GUAM POWER AUTHORITY

AMENDMENT NO.: II

INVITATION FOR BID NO.: GPA-022-18

PHYSICAL SECURITY AND ACCESS CONTROL SYSTEM (ACS) REPAIR AND UPGRADE AT VARIOUS GPA LOCATIONS

FIRST FLOOR EXIT ROUTE

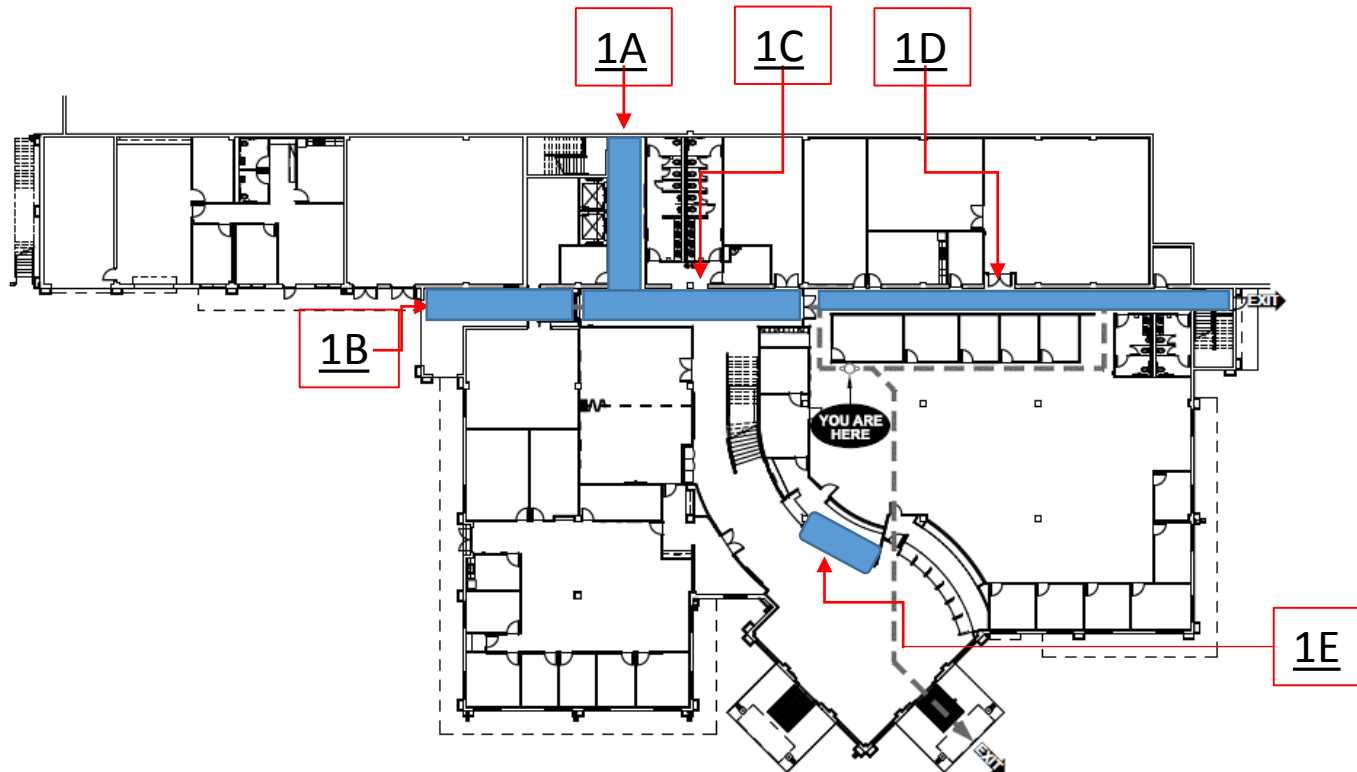
9. Please provide drawings with hallway measurements that Melvyn Kwek said would be made available during the site survey.

1A – LOBBY NEXT TO THE ELEVATOR (39.5 ft)

1B – EMPLOYEE ENTRANCE/EXIT (40 ft)

1C – CUSTOMER SERVICE ENTRANCE/EXIT TO
EMPLOYEE ENTRANCE (58 ft)

1D – CUSTOMER SERVICE HALLWAY (101.5 ft)

1E – CASHIERS

** SHADED BLUE AREAS REQUIRE CAMERA COVERAGE

Refer to Attachment B.

SECOND FLOOR EXIT ROUTE

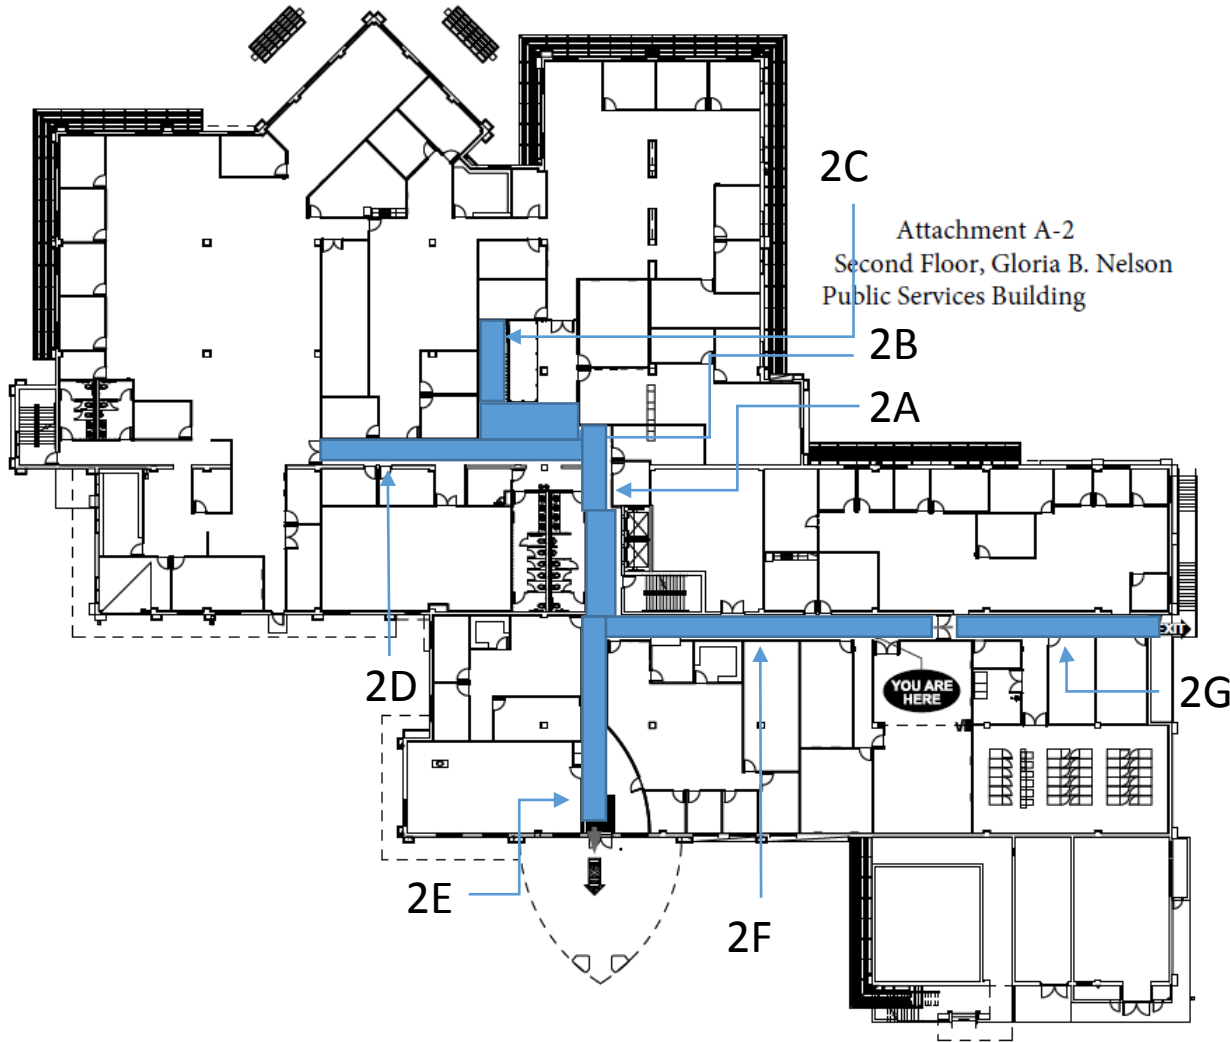
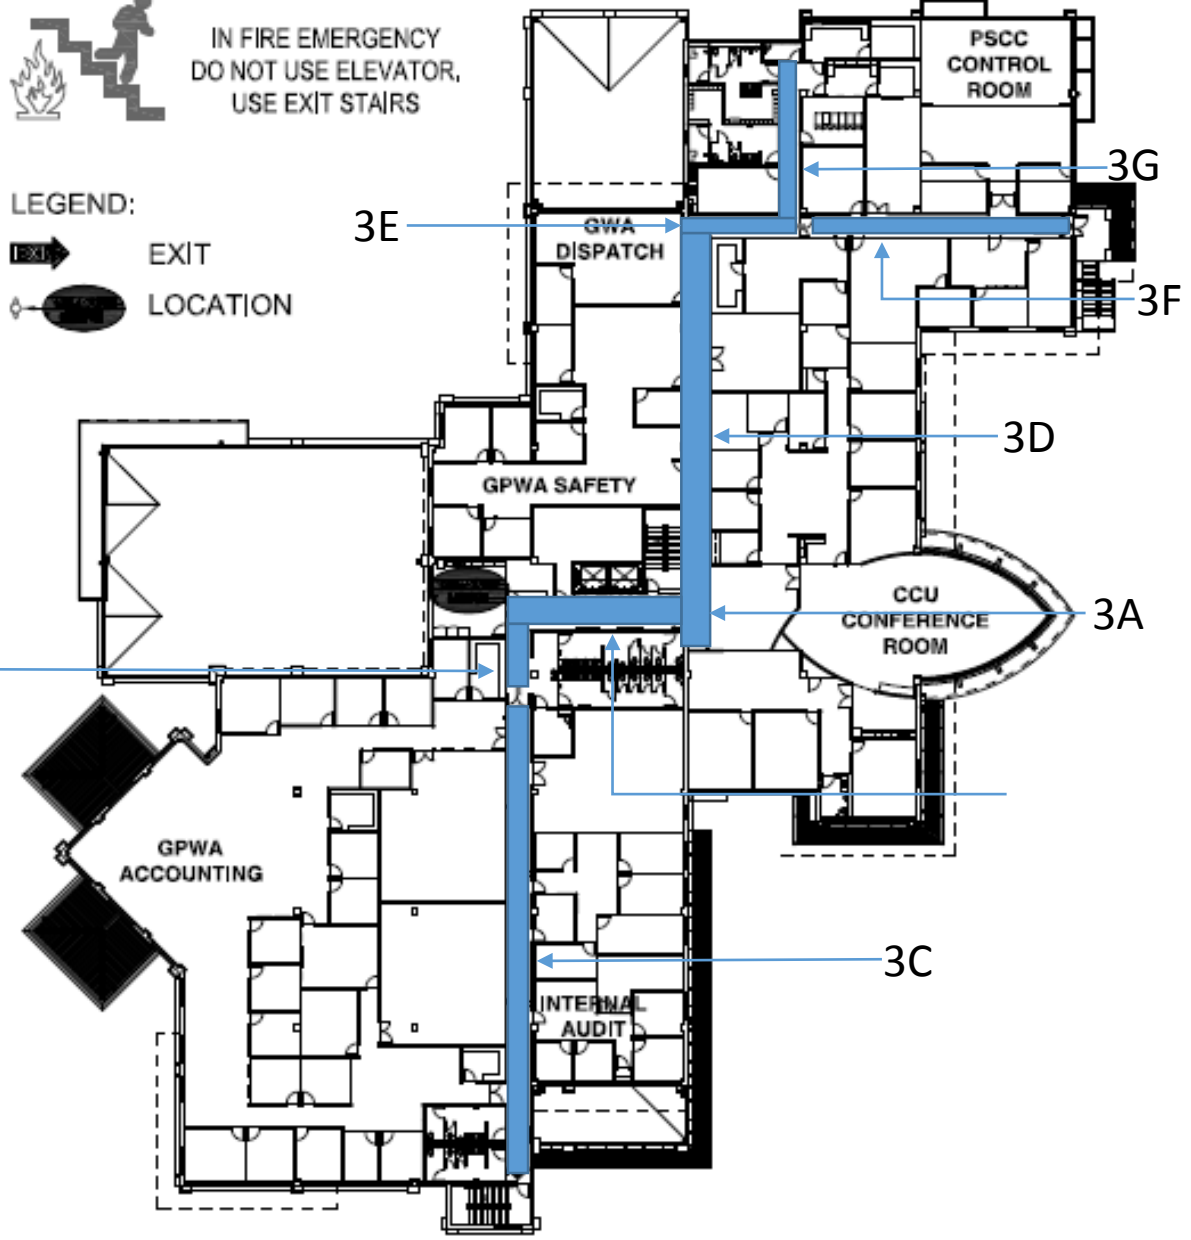
- 2A – LOBBY AREA NEAR ELEVATOR (58 ft *w/2B)
- 2B – COMM/ELECTRICAL ROOMS (Combined w/2A)
- 2C – STAIRWELL TO MAIN LOBBY (42 ft)
- 2D – ENGINEERING HALLWAY (79 ft)
- 2E – EMPLOYEE ENTRANCE UP TO HR/IT HALLWAY (52 ft)
- 2F – HR/IT HALLWAY (90 ft)
- 2G – IT HALLWAY (57 ft)

** SHADED BLUE AREAS REQUIRE CAMERA COVERAGE

THIRD FLOOR EXIT ROUTE

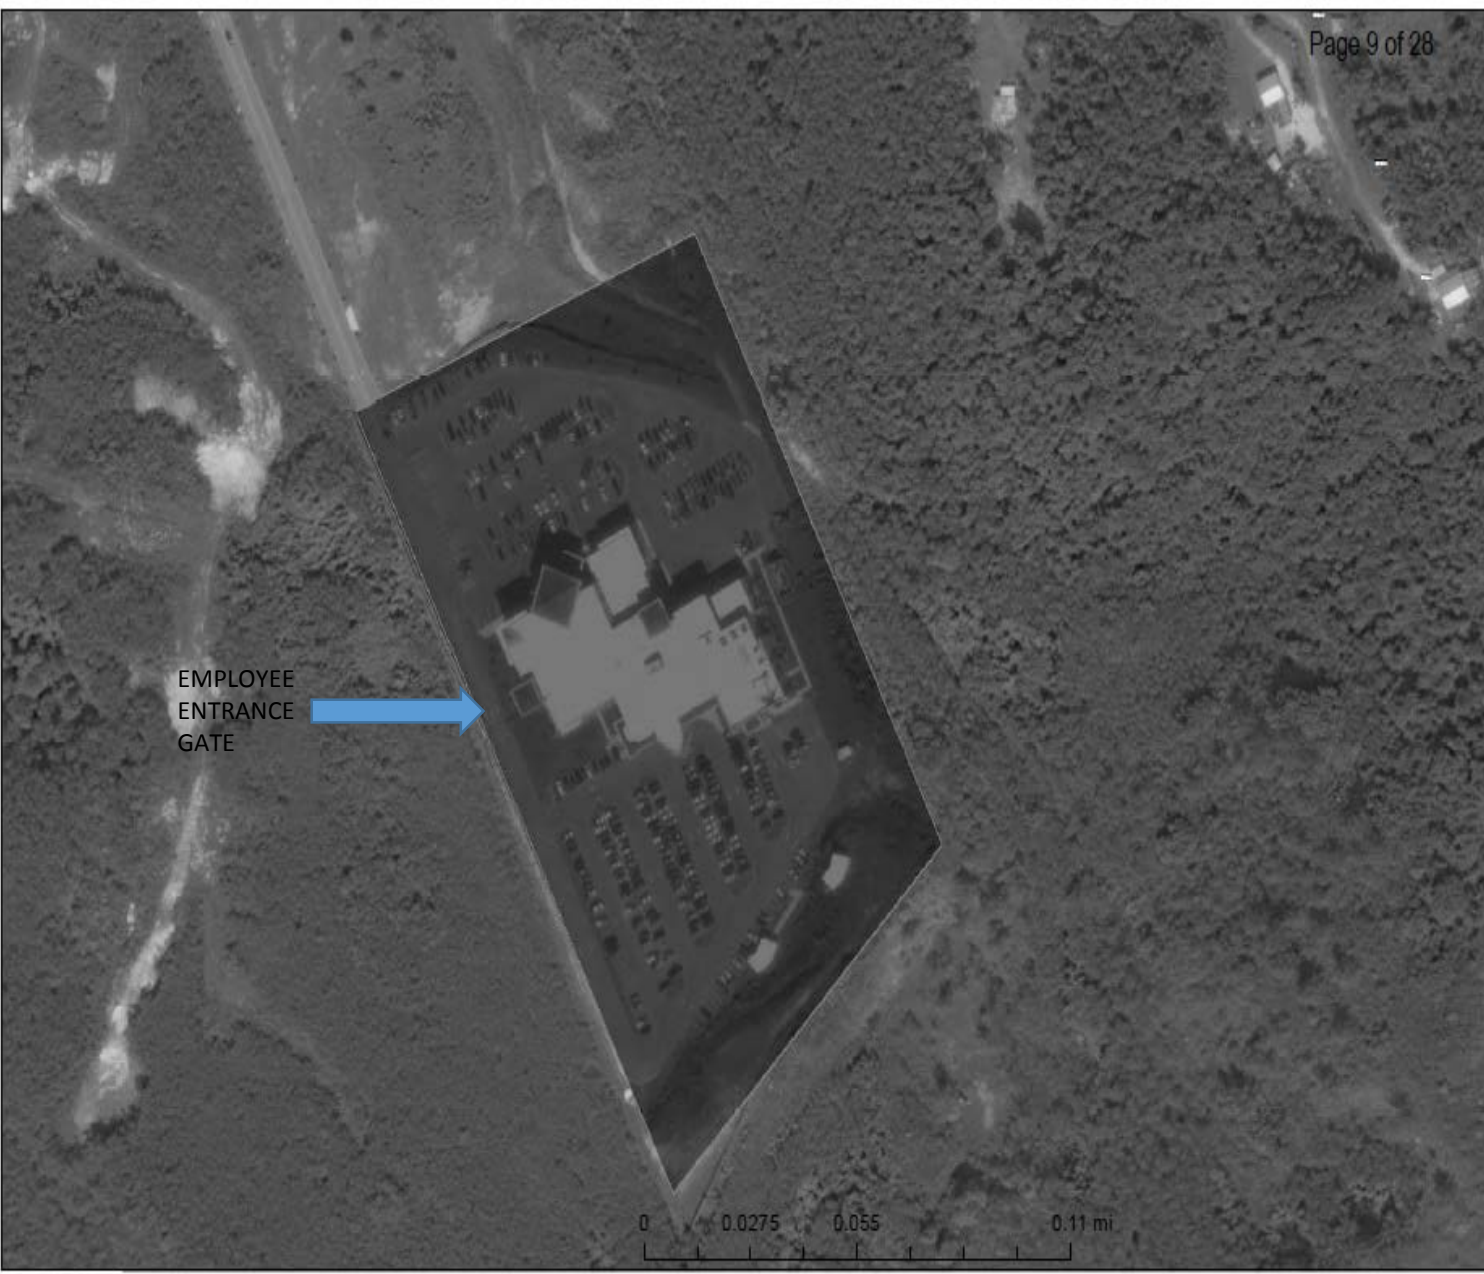
- 3A – THIRD FLOOR ELEVATOR (40 ft)
- 3B – ENTRANCE TO FINANCE (23.5 ft)
- 3C – FINANCE HALLWAY (125 ft)
- 3D – EXECUTIVE HALLWAY (106 ft)
- 3E – ENTRANCE TO PSCC (29 ft)
- 3F – PSCC HALLWAY (70.5 ft)
- 3G – PSCC BATHROOM HALLWAY (44.5 ft)

** SHADED BLUE AREAS REQUIRE CAMERA COVERAGE
